1. **Release Date:** 02/09/2017
2. **Service Letter No.:** SL23 66-12020
3. **Reason for Change:** Explicit instructions to properly adjust tie rods.
4. **Part/Assembly No.:** 66-12020
5. **Float Model Affected:** 6650
6. **Disposition of Product in Field:** NA
7. **Approval:** All information provided is in accordance with approved data.
8. **Corrective Action:** Informational Only
9. **Time Required:** Less than 1 hour
10. **Payments:** None

### Instructions for Tie Rod Adjustments:

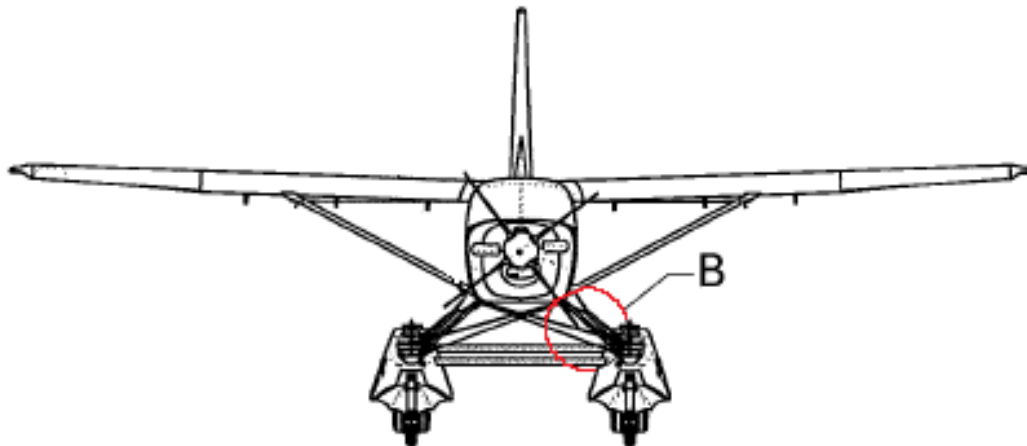
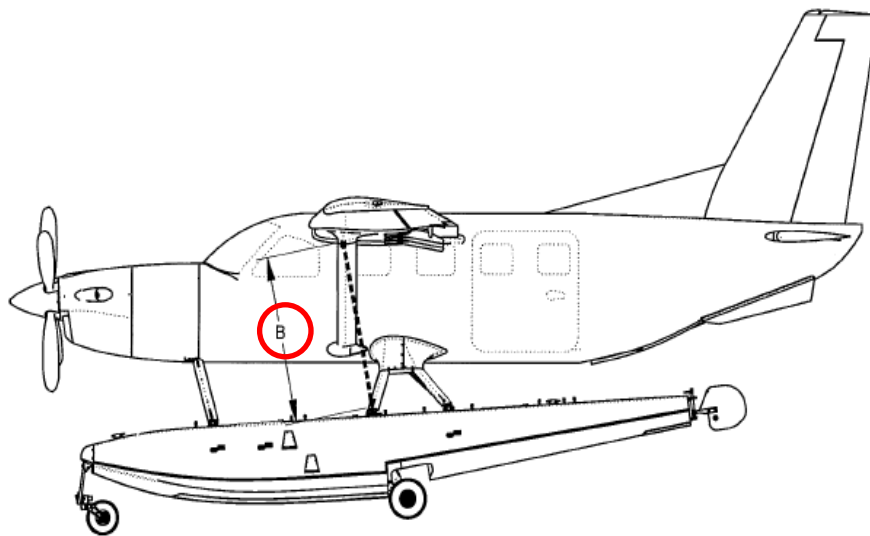
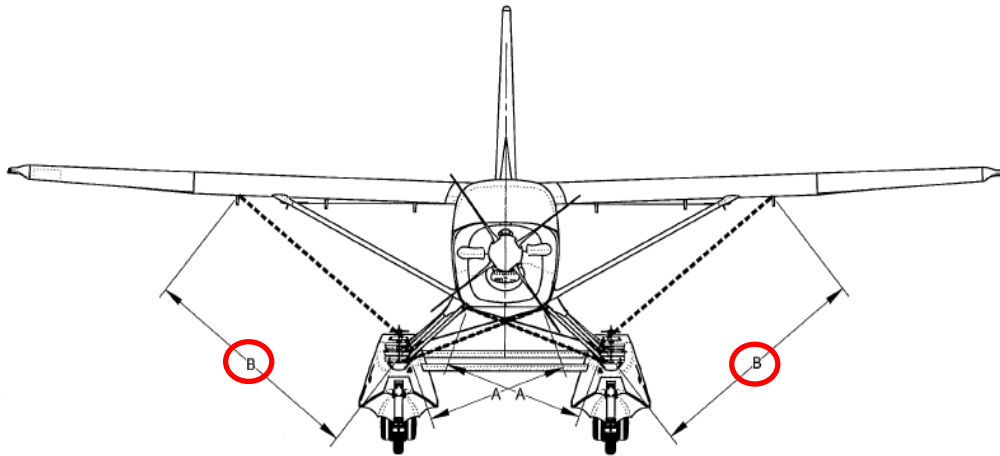
2. Assure even thread insertion in clevis ends. Minimum thread shall be evident past the witness hole.
3. FWD tie rod lengths, pin to pin, shall match (LHS and RHS).
4. AFT tie rod lengths, pin to pin, shall match (LHS and RHS).

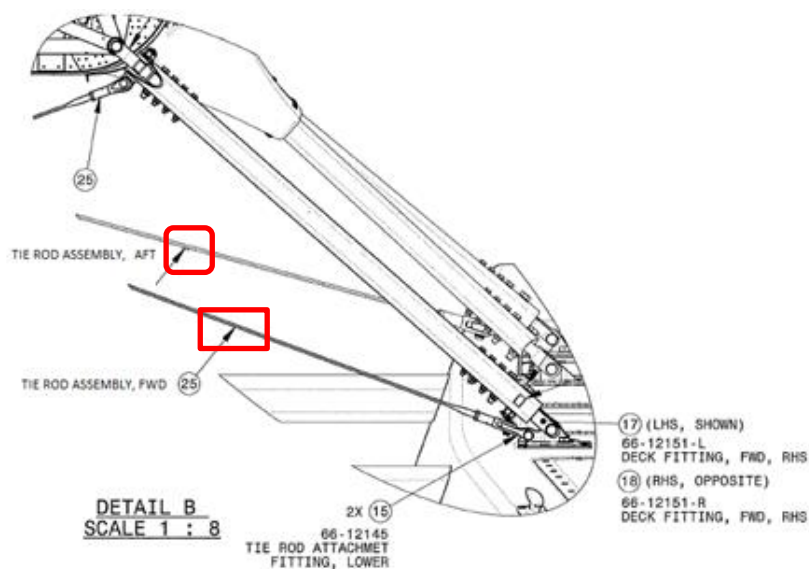
5. Position of the mid deck fitting to wing strut tie down shall match within 1" LHS to RHS. [Ref Dimension B, (see below) using like points of reference for each side].
